Interactive comment on “Effects of seasonality on the distribution of hydrological extremes” by P. Allamano et al.

P. Allamano et al.

Received and published: 26 August 2011

Fig. 1. Exponential ($E(x)$, dashed) versus seasonal ($F(x)$, solid) distribution with $a_{\alpha}=0.5$, $a_{\lambda}=0.5$ and $\delta=\pi$

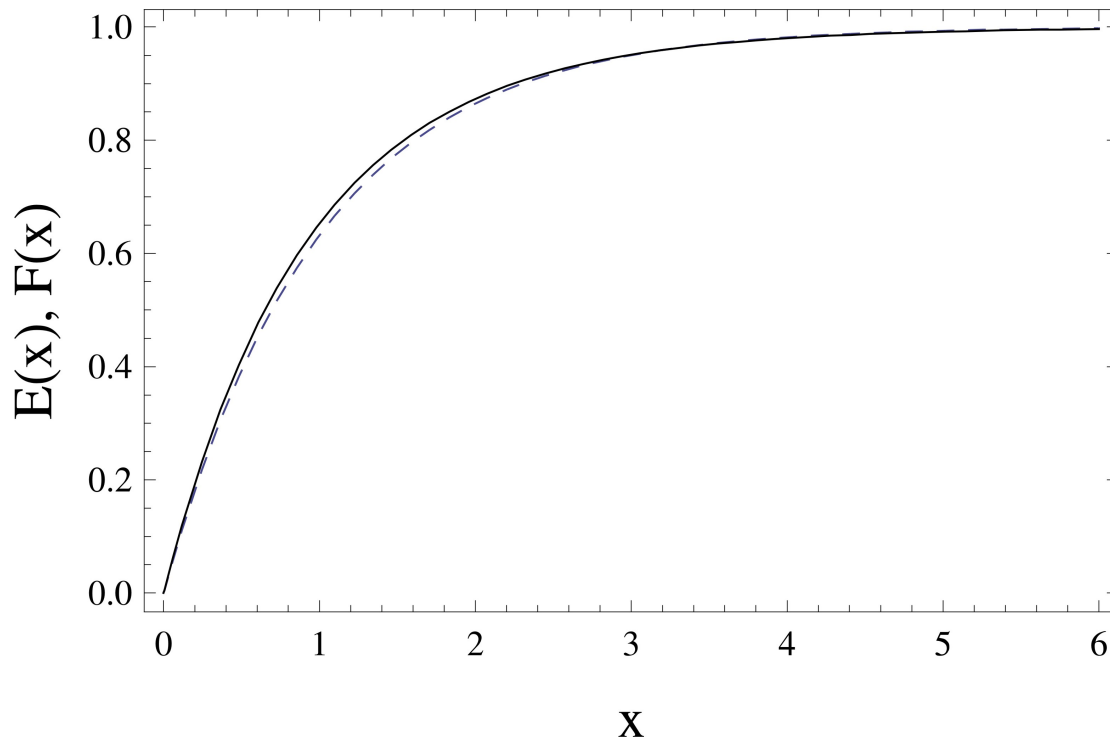
P4796, L20. Here the authors argue that statistical tests typically fail to recognize that the marginal distribution of exceedances is not exponential. We have not tried to reproduce the test results, but are curious about the results. For example, in Figure 2, with the case of $\lambda = 50$ and a 20 year record, one would have on average of 1000 observations in a sample. This is a very large sample and goodness-of-fit tests should be able to pick up discrepancies from the assumed distribution. In fact, when samples are very large, statistical tests tend to become "too powerful" and are usually avoided. This is the well-known issue of "statistical significance" versus "practical significance".

Goodness-of-fit tests are not able to recognize the difference between the two distributions because the distributions are indeed very similar, in particular in the central part of the distribution (see for example Fig. 1 of this document). However, in the right tail of the distribution the differences are large enough to produce a 5-fold underestimation of the return period associated to an event. Despite the very large sample size, this is therefore a situation where the differences are practically significant (for example, for design purposes it is important to know that neglecting seasonality could entail underestimation), but they are not statistically significant in a large percentage of cases.

Fig. 2. Return period ratios evaluated for the 294 stations (the color scale refers to the resulting range of variation of $R_T^{(POT)}$)

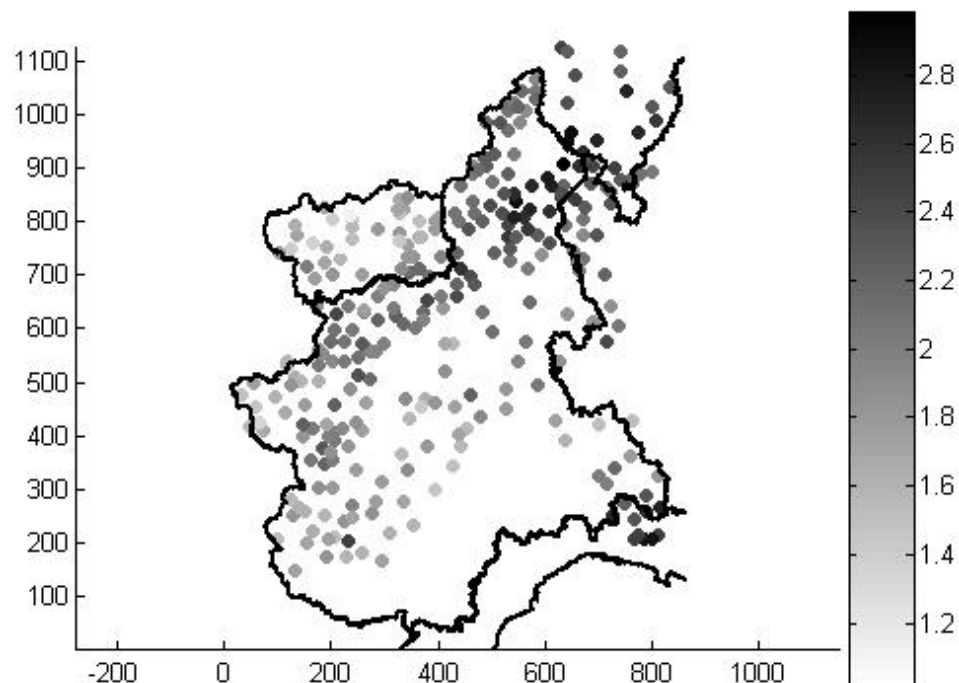
P4799, L6. A value $\lambda = 20$ and a record length of 74 years will give sample of 1500 events. Our guess is that there would be significant benefit in raising the threshold, because the lower the threshold, the more significant the problem of seasonality will be. For estimation of a, say, 100-year event, one is probably better off using only the 100 or 200 largest values.

As suggested by this Referee we have tried to raise the threshold to 50 mm, which

corresponds to about $\lambda = 5$ events per year over the whole dataset. $R_T^{(POT)}$ obtained for each station are reported in the Fig. 2 below. The values - as expected - are a bit lower than the ones shown in Fig. 6 (of the manuscript) but still relevant and worth to be accounted for.
